DEPARTMENT OF TRANSPORTATION  
STATE OF GEORGIA

FILE: CSSTP-0007-00(414) Camden County OFFICE: Program Delivery  
PI No.: 0007414  
CR90/Colerain Rd. from I-95 to Kings Bay Rd. DATE: January 31, 2012

SUBJECT: Value Engineering Study-Reversal

CSSTP-0007-00(414)  
Camden County  
Widening Colerain Road from I-95 to Kings Bay Road  
P.I. 0007414

SUBJECT TYPICAL SECTIONS : RURAL SHOULDER  
W/ 4' BIKE LANE

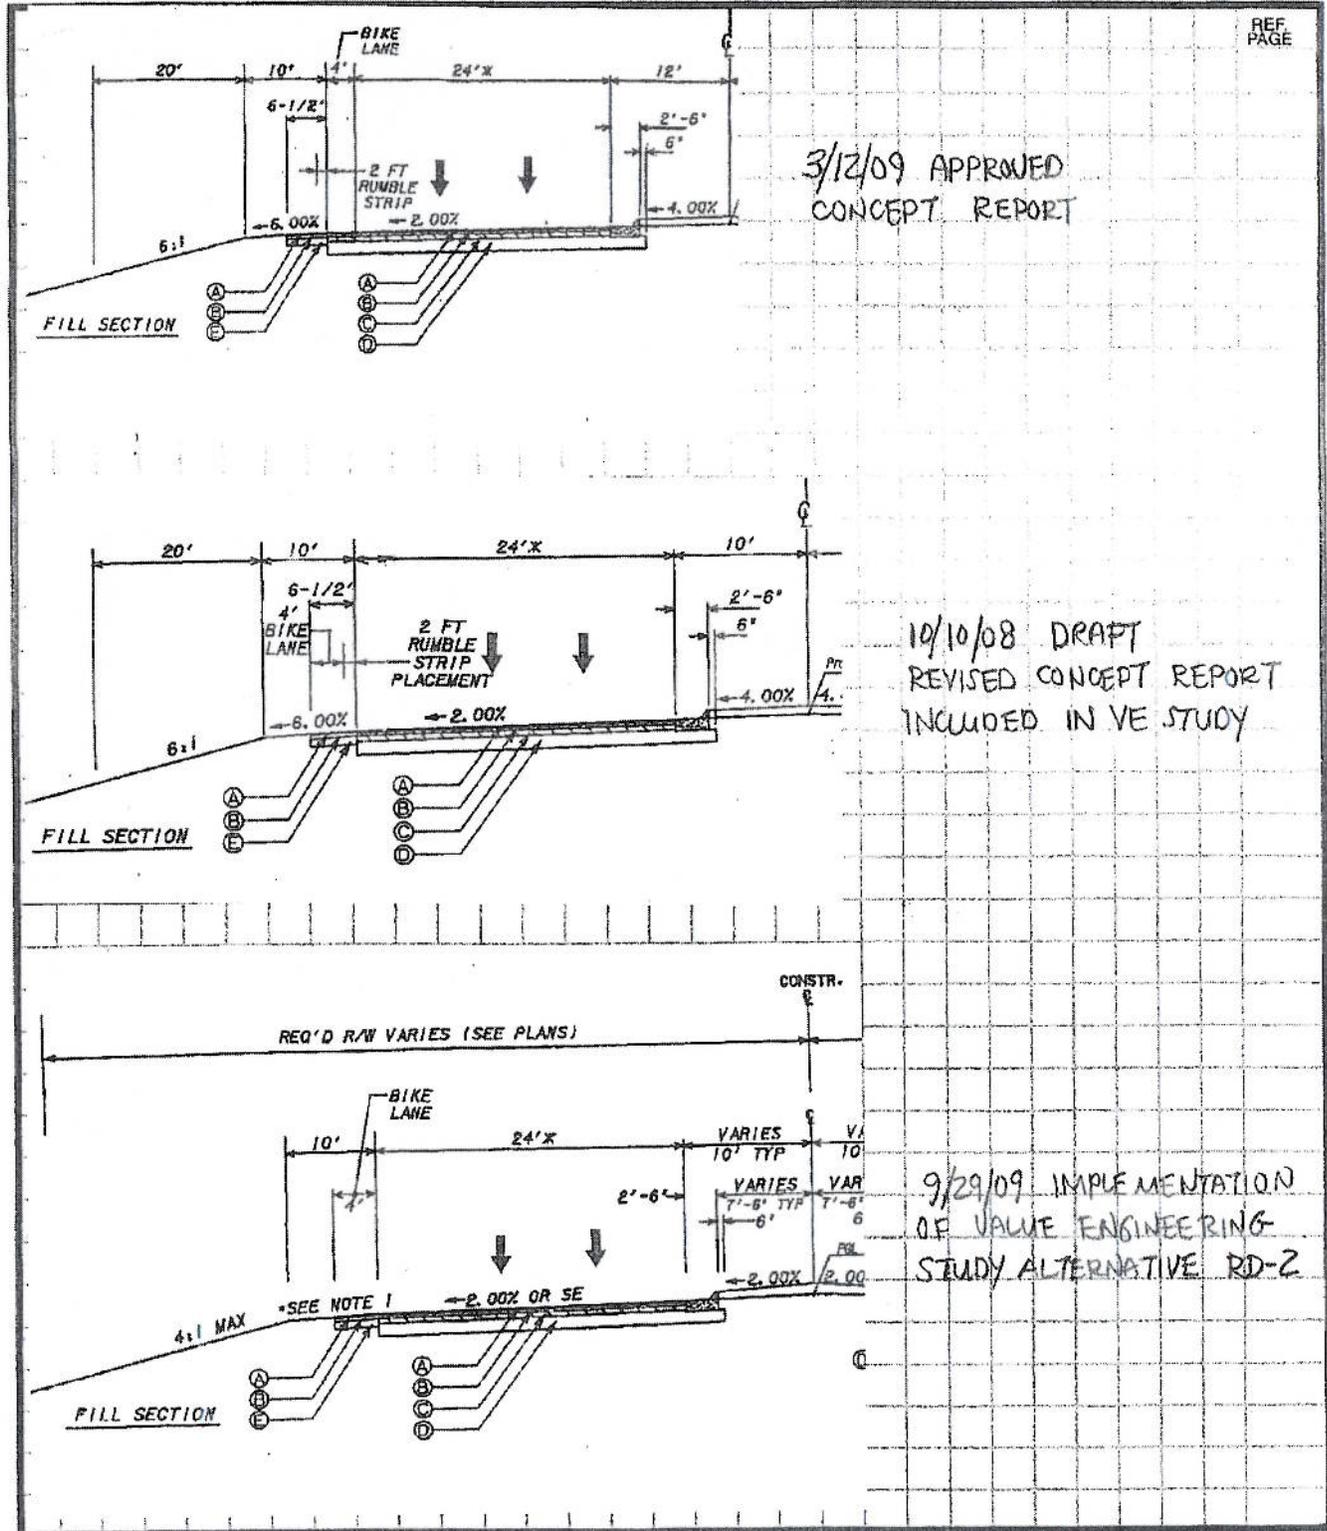
Review of the revised concept report determined that the proposed 10-foot rural outside shoulder consisting of 4-foot paved and 6-foot grass did not meet the requirements of a 6-foot, 6-inch paved shoulder for a 4-foot bike lane including a 16-inch rumble strip offset 12-inches from the travel way per GDOT Design Policy Manual, Section 9.5.2 Bicycle facility Design 1. On-street Bicycle Facility page 9-11 revised March 1, 2011.

MAAI requests reversing the VE recommendation RD-2 as recommended by the Office of Design Policy and Support to incorporate a proposed 10-foot rural outside shoulder consisting of 3-foot, 6-inch grass and 6-foot 6-inch paved to accommodate a 4-foot bike lane and 16-inch rumble strip offset 12-inches from the travel way in each direction.
